DUNNWOOD SUBDIVISION, PHASES TWO-FOUR

APPLICATION NUMBER 12 DATE April 19, 2018

APPLICANT Dunnwood Subdivision, Phases Two - Four

REQUEST Subdivision

DETAIL SITE PLAN

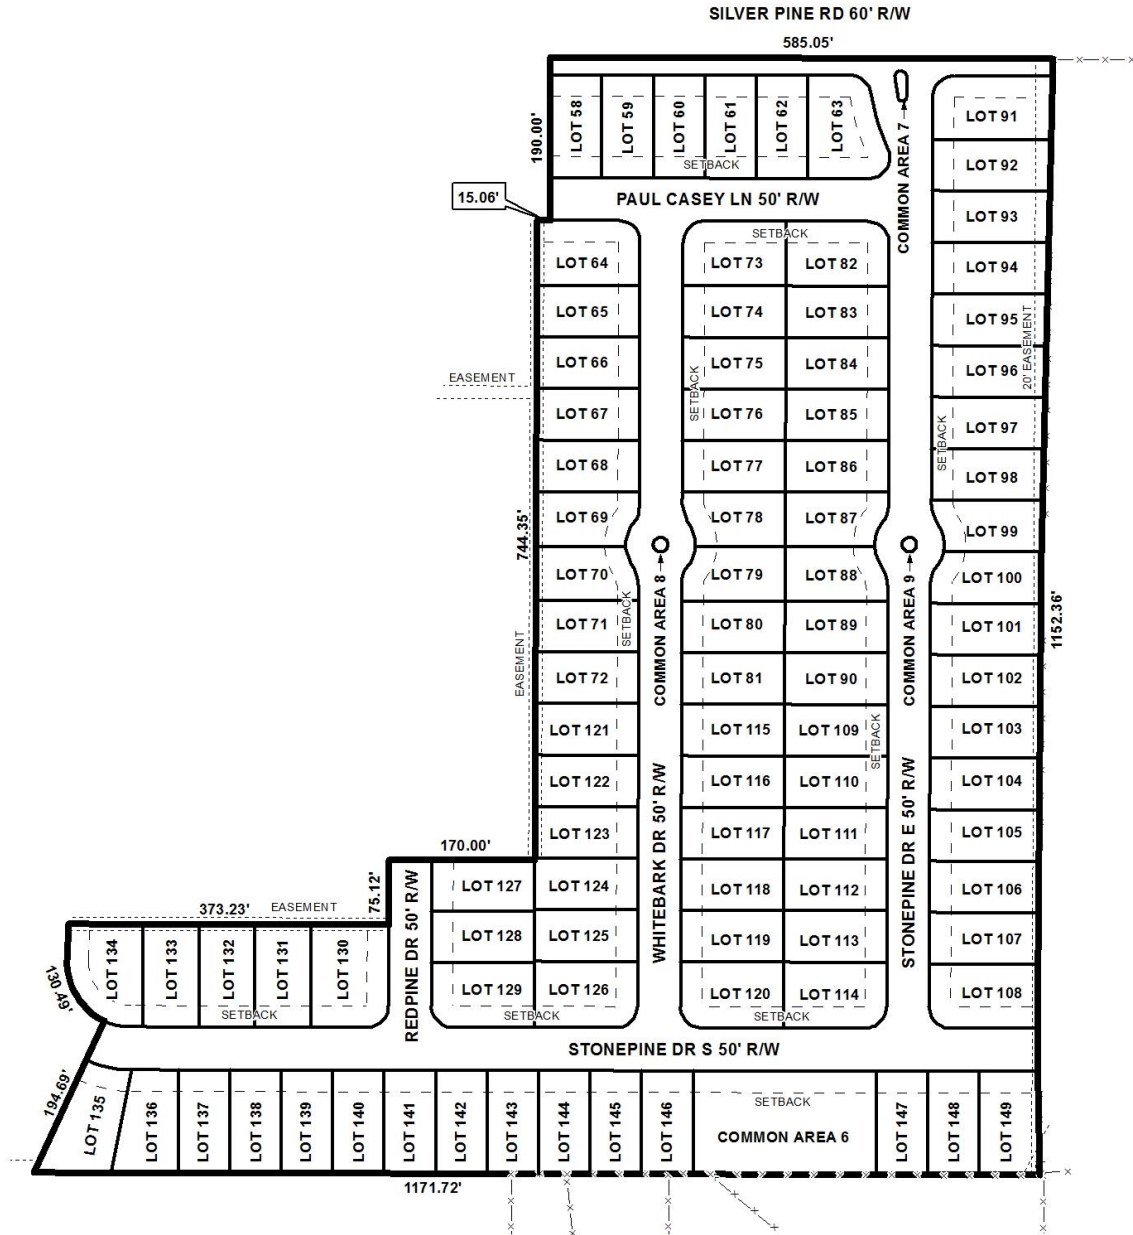
The currently proposed layout of the lots is similar to the layout originally approved, with the exception of the introduction of two traffic circles, and some changes to the total square footage of several lots. All lots meet the minimum square footage for new lots with public water and

sanitary sewer. If approved, the sizes of all lots and common areas should be provided in both square feet and acres.

The 25' minimum building setback line appears to be depicted along all frontages, but is not labeled as such. If approved, the minimum building setback line should be labeled. There is a water and sewer easement along the Eastern property line, as well as drainage easements along the West of Lots 64-72 and 121-126 and to the North of Lots 130-134. All easements should be labeled as such, with a note on the Final Plat stating that no structures are to be erected in any easements.

As a means of access management, all lots should be limited to one curb cut each, with Lots 58-63 and Lot 91 denied direct access to Silver Pine Road, if approved.

- 1) retention and labeling of the 25' minimum building setback line along all street frontages;

- 2) placement of a note on the Final Plat stating that Lots 58-63 and Lot 91 are denied direct access to Silver Pine Road;
- 3) placement of a note on the Final Plat stating that all lots and common areas are limited to one curb cut each, with the size, location and design to be approved by Mobile County Engineering;

- 4) revision of the plat to label the size of each lot and common area in both square feet and acres, or the furnishing of a table on the Final Plat providing the same information;

- 5) depiction and labeling of all easements on the site;
- 6) placement of a note on the Final Plat stating that no structures may be constructed or placed within any easement;
